ATTACHMENT B

PROPOSED CHANGES TO APPENDIX A,
TECHNICAL SPECIFICATIONS OF FACILITY
OPERATING LICENSES NPF-18 AND NPF-11

REVISED PAGES

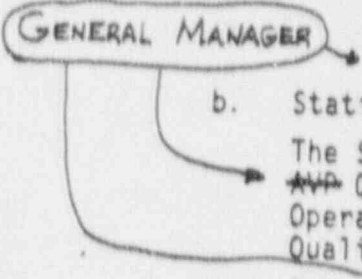
The Superintendent of the Offsite Review and Investigative Function shall: (1) provide directions for the review and investigative function and appoint a senior participant to provide appropriate direction, (2) select each participant for this function, (3) select a complement of more than one participant who collectively possess background and qualifications in the subject matter under review to provide comprehensive interdisciplinary review coverage under this function, (4) independently review and approve the findings and recommendations developed by personnel performing the review and investigative function, (5) approve and report in a timely manner all findings of non-compliance with NRC requirements to the Station Manager, Vice President BWR Operations, Manager of QA/NS, ~~Assistant Vice President (AVP) Quality Programs and Assessment, and the Senior Vice President - Nuclear Operations.~~ During periods when the Superintendent of Offsite Review and Investigative Function is unavailable, he shall designate this responsibility to an established alternate, who satisfies the formal training and experience for the Superintendent of the Offsite Review and Investigative Function. The responsibilities of the personnel performing this function are stated below. The Offsite Review and Investigative Function shall review:

GENERAL
MANAGER →
